Change Order

PROJECT (Name and address):	CHANGE ORDER NUMBER: 004	OWNER: <input checked="" type="checkbox"/>
Rapid City Utility Maintenance Facility Rapid City, South Dakota	DATE: June 29, 2015	ARCHITECT: <input checked="" type="checkbox"/>
TO CONTRACTOR (Name and address):	ARCHITECT'S PROJECT NUMBER: 13373	CONTRACTOR: <input checked="" type="checkbox"/>
SECO Construction, Inc. P.O. Box 2921 Rapid City, SD	CONTRACT DATE: September 17, 2014	FIELD: <input type="checkbox"/>
	CONTRACT FOR: General Construction	OTHER: <input type="checkbox"/>

Construction Change Directive

PROJECT: <i>(Name and address)</i> Rapid City Utility Maintenance Facility Rapid City, South Dakota	DIRECTIVE NUMBER: 003 DATE: April 13, 2015 CONTRACT FOR: General Construction	OWNER: <input checked="" type="checkbox"/> ARCHITECT: <input checked="" type="checkbox"/> CONSULTANT: <input type="checkbox"/> CONTRACTOR: <input checked="" type="checkbox"/> FIELD: <input type="checkbox"/> OTHER: <input type="checkbox"/>
TO CONTRACTOR: <i>(Name and address)</i> SECO Construction, Inc. P.O. Box 2921 Rapid City, SD	CONTRACT DATED: September 17, 2014 ARCHITECT'S PROJECT NUMBER: 13373

CCD #: 003	CITY OF RAPID CITY UTILITY MAINTENANCE FACILITY	UDA #13373
REVISED ENLARGED PLAN - C5/A-401		
Scale: 3/16 = 1'-0"	DATE: 04/13/15	A1

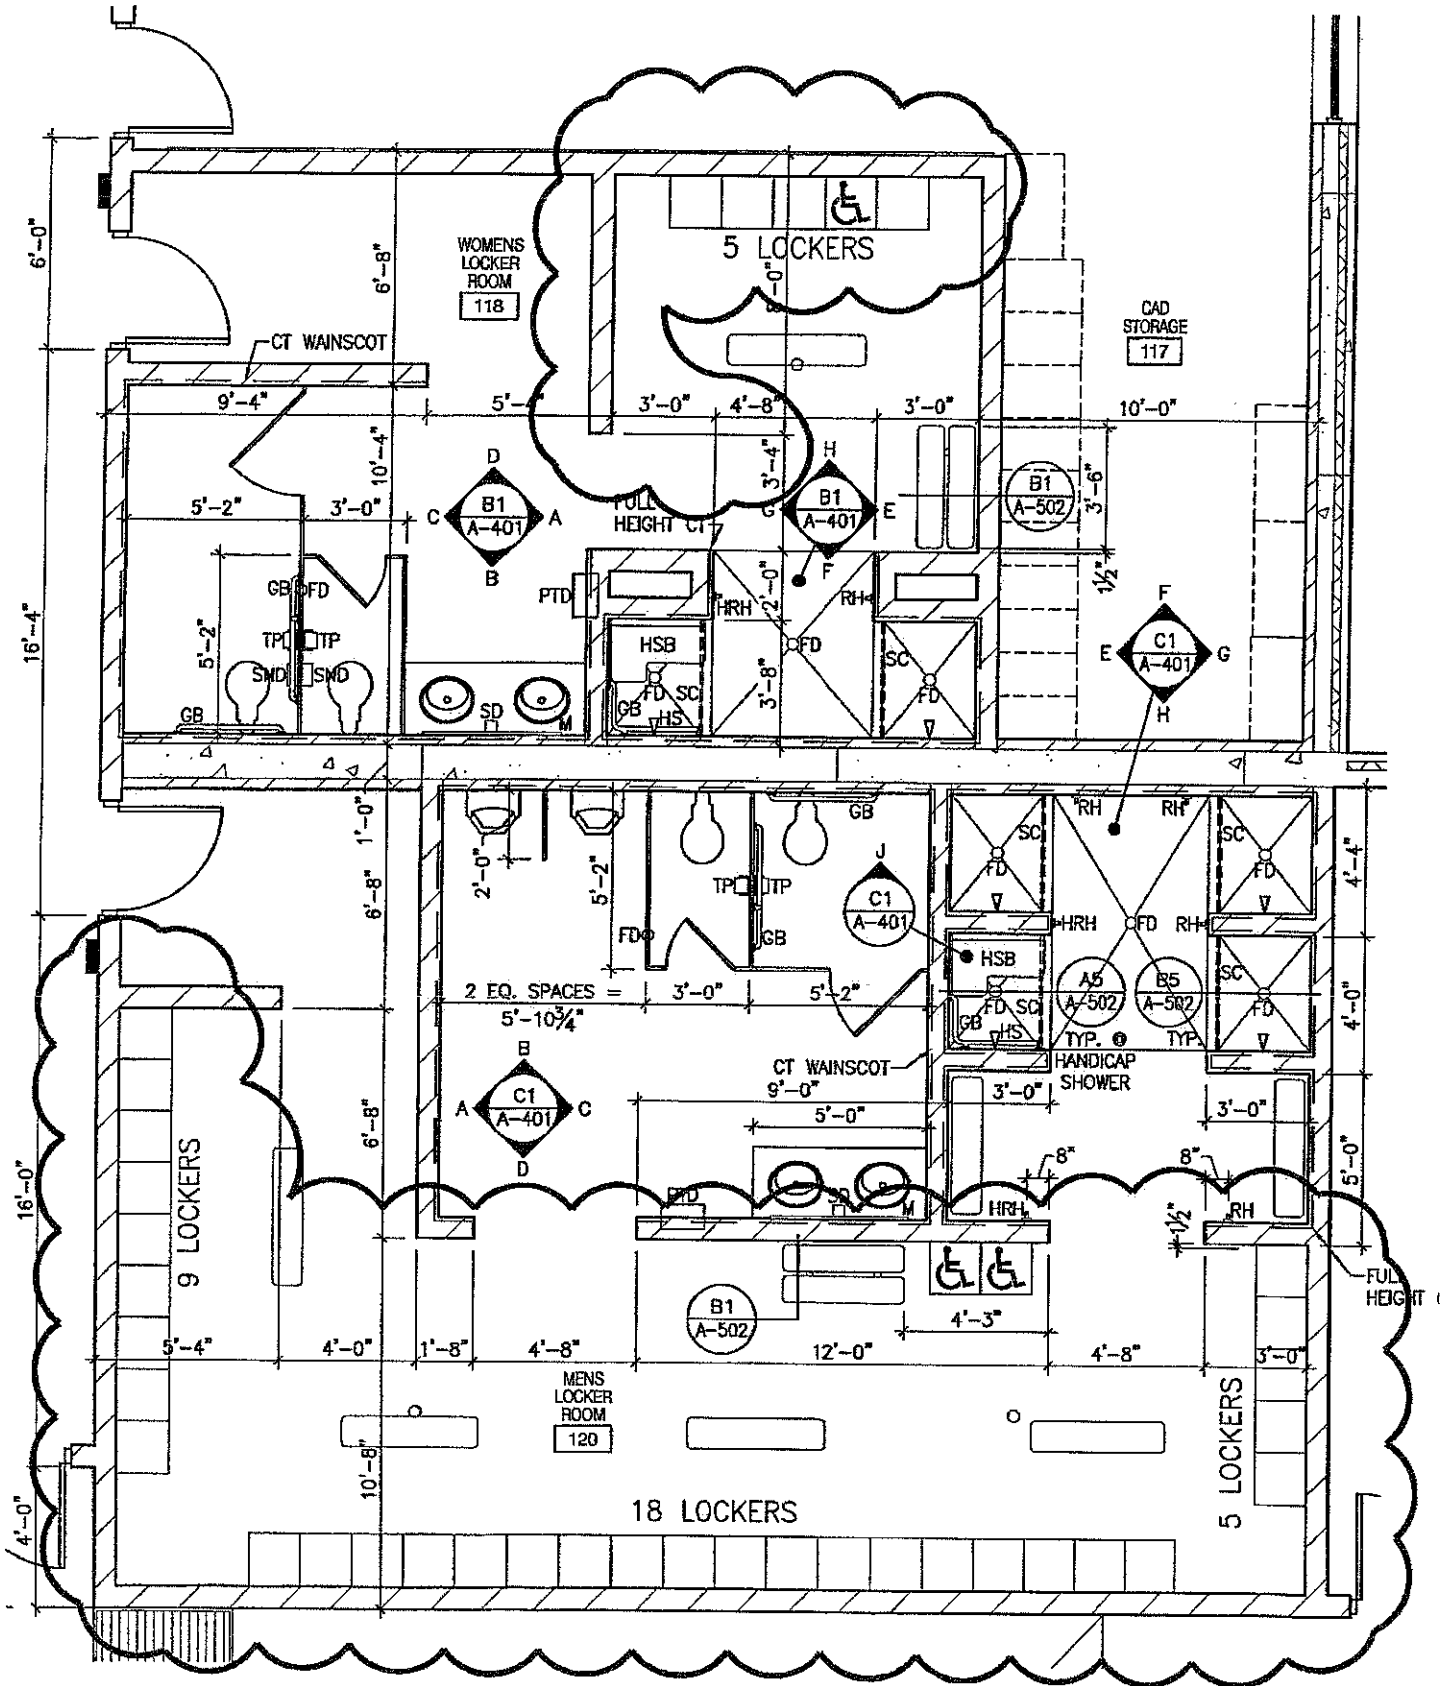
- The proposed basis of adjustment to the Contract Sum or Guaranteed Maximum Price is:
 - Lump Sum decrease of \$0.00
 - Unit Price of \$ per
 - As provided in Section 7.3.3 of AIA Document A201-2007
 - As follows: Provide 32-18" x 18" x 72" Lockers and 2-18" x 18" x 72" ADA Lockers in Mens Locker Room-120 in lieu of 24" x 24" x 72" Lockers. Womens Locker Room -118, provide 5-18" x 18" x 72" Lockers including one ADA in lieu of 24" x 24" x 72" lockers. Extend north-south CMU wall 1'-4" in length between entry and locker room. Cost to be determined.
- The Contract Time is proposed to (remain unchanged). The proposed adjustment, if any, is 0 days.

We propose to provide the locker changes and additional CMU wall as outlined in Construction Change Directive #3 dated April 13, 2015 for an additional cost of \$2,139.00. The cost summary sheet for this work and associated documentation are enclosed for your review.

This proposal is based on changing the locker manufacturer from Republic Storage Systems to Lyon Workspace Products. Since the manufacturer has changed, the color will change to Lyon's Gray Beige. Product data for the new manufacturer will be included in the closeout documents.

MEZZANINE HVAC PLAN

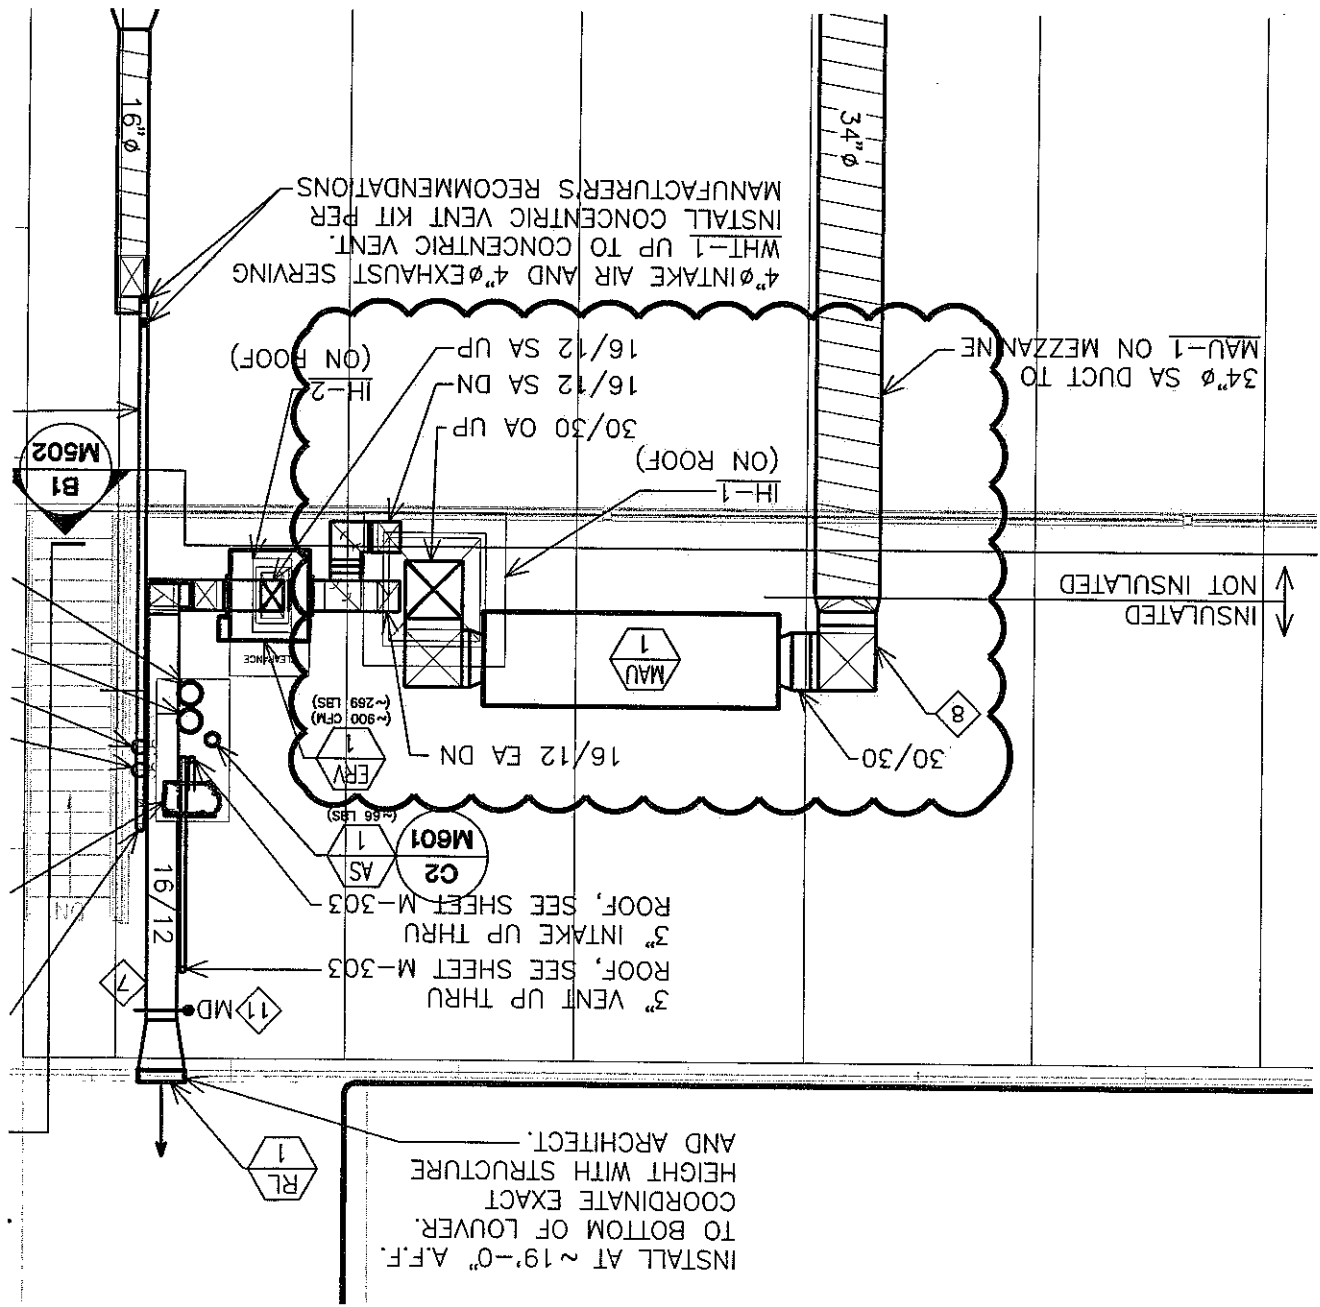
1. Move MUA-1 so that there is a minimum of 42" from guard rail to side of make up air unit cabinet as indicated on attached sketch. Housekeeping pad will need to be extended to the north a bit and a small amount of additional ductwork/fittings will be required.

The following price is to move the MUA#-1 to the north 43 inches from the railing as per drawing. This will entail the extension of the 34" spiral and re-routing the Outside Air ductwork.

B1 **FIRST FLOOR HVAC PLAN**
 SCALE: 1/8" = 1'-0"

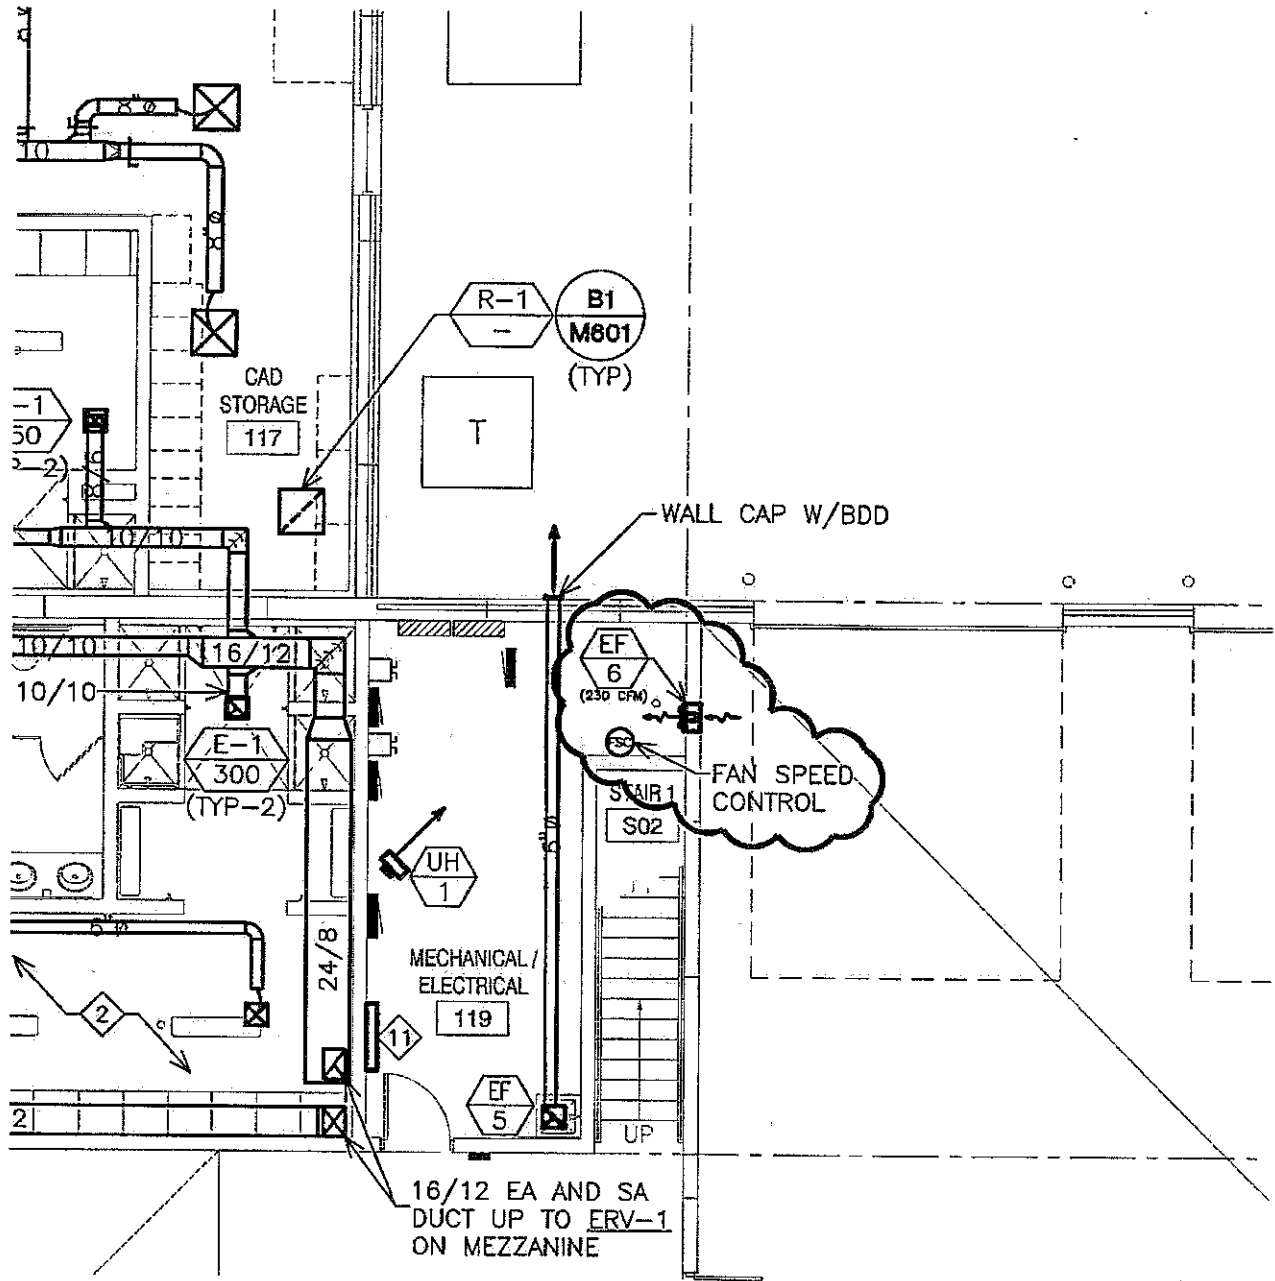
1. Mechanical: Provide new axial propeller fan, EF-6 as indicated on attached sketch, MSK20-1 and MSK20-2. Install fan as high as possible, coordinate installation location with plumbing and electrical contractor. Provide FSC, wall sleeve with front and rear guards and disconnect. Power fan as indicated on attached sketch, MSK20-2.
2. Electrical: Provide MRT, labeled and power from dedicated branch circuit, EQ-57.

The following price is to furnish and install EF#-6 for the electrical room.

EXHIBIT A - CCD #4

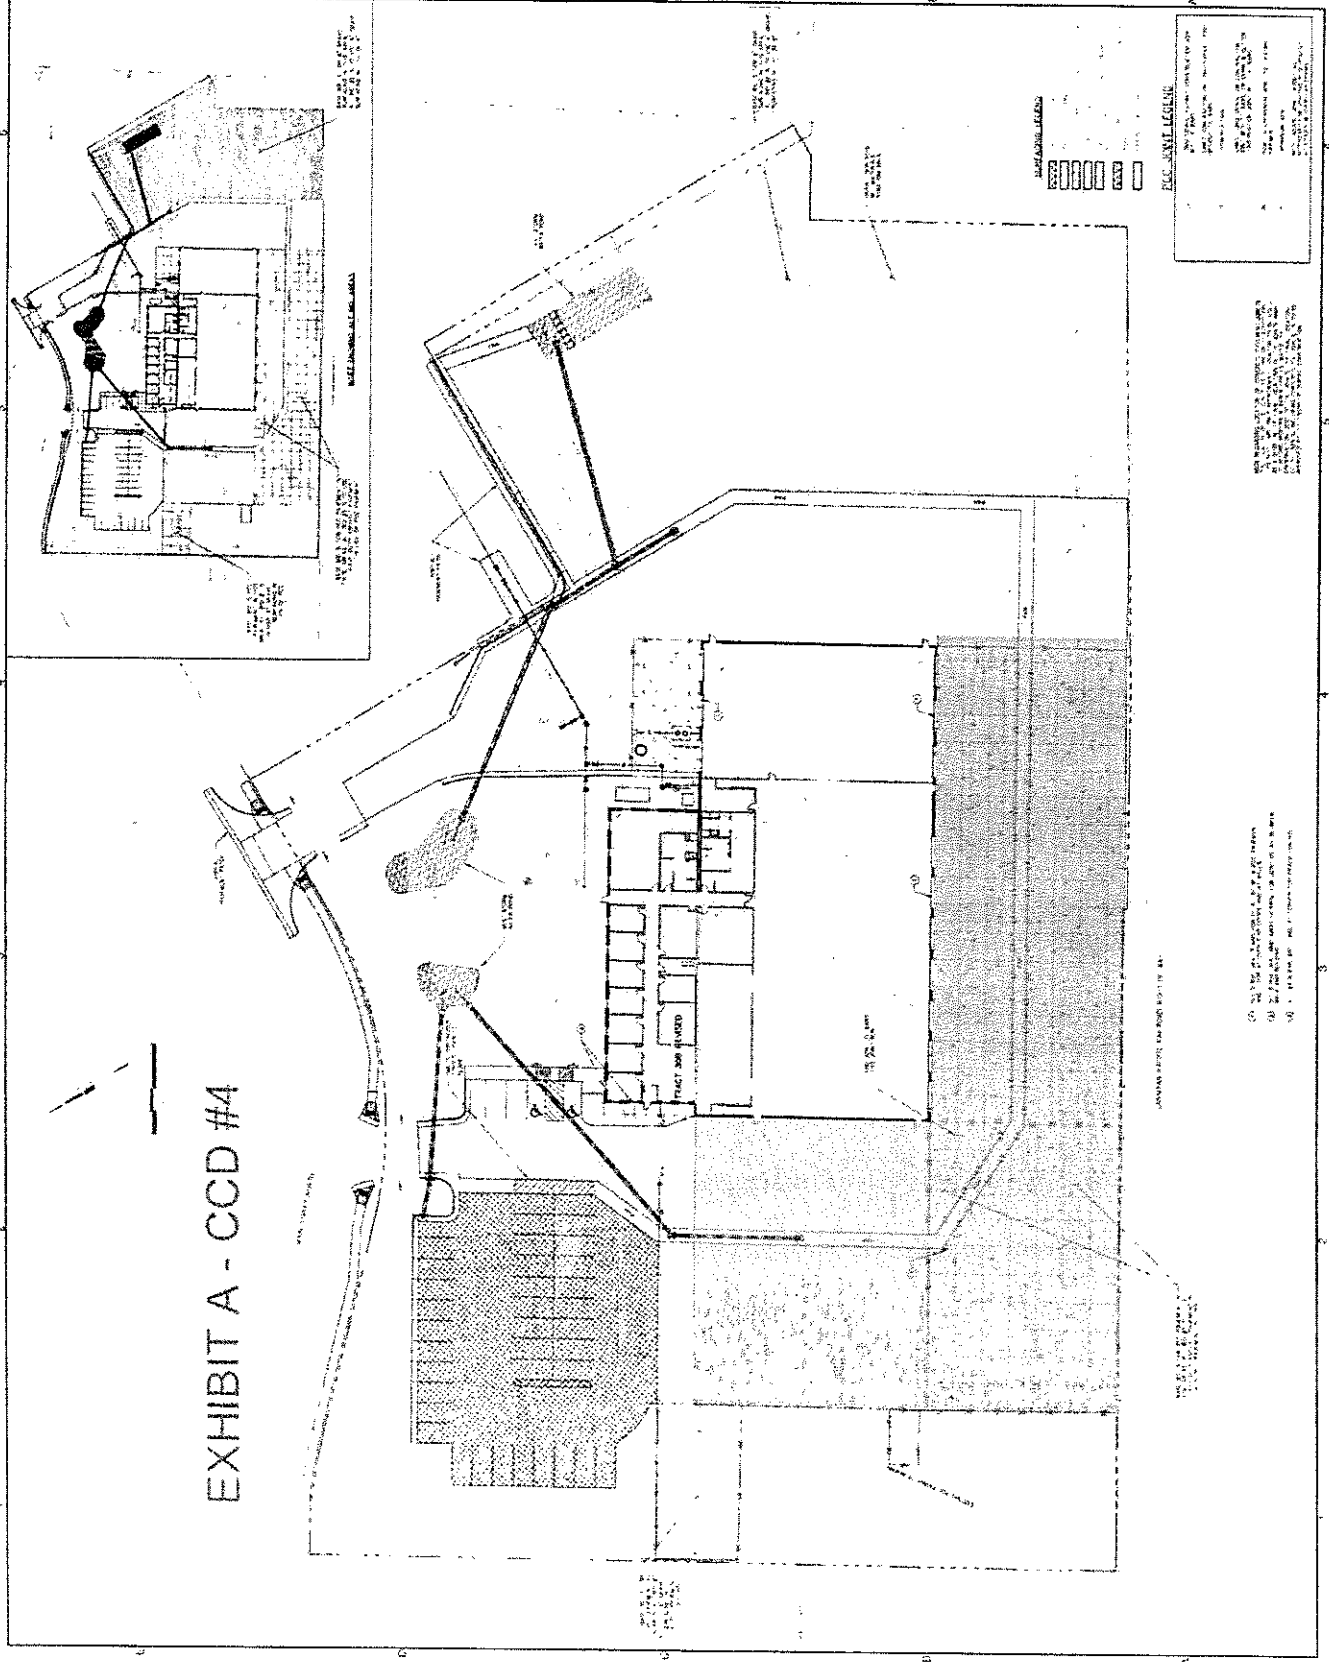
On 5/26/2015, direction was given to G.C. to replace unsuitable soils at southwest corner of facility with geogrid, 4" on-site material, and 12" sugar rock. Contractor shall provide unit cost for on-site material. Unit prices will be used to determine final costs.

We propose to provide the additional soil stabilization as outlined in Construction Change Directive #4 dated June 8, 2015 for an additional cost of \$44,599.19. The work was completed based on using unit prices provided in the contract. Additional geogrid cost was calculated based on rolls placed. Digouts with onsite fill are calculated based on the actual area placed and theoretical depth specified. Granular and rock material cost is based on weigh tickets for material placed and quantity converted from tons to CY. The area covered under CCD #4 is south and west of the building as shown on Exhibit A – CCD #4 that is attached. Summary is as follows:

<u>UNIT PRICE No. 1 – Stabilization with Geogrid</u>	
17 Rolls x 355 SY/Roll = 6035 SY @ \$2.15/SY =	\$12,975.25
<u>UNIT PRICE No. 2 – Digouts with Onsite Materials</u>	
12,232 SF x 0.33 FT deep ÷ 27 CF/CY = 151 CY @ \$9.68 =	\$1,461.68
<u>UNIT PRICE No. 3 – Digouts with Type 4 Foundation Material</u>	
844.33 Tons ÷ 1.4 Tons/CY = 603.09 CY @ \$38.70/CY =	\$23,339.69
<u>UNIT PRICE No. 4 – Removal and Replacement of Existing with Engineered Fill</u>	
360.08 Tons ÷ 1.9 Tons/CY = 189.52 CY @ \$36.00/CY =	<u>\$6,822.57</u>
TOTAL COST CHANGE ADD	\$44,599.19
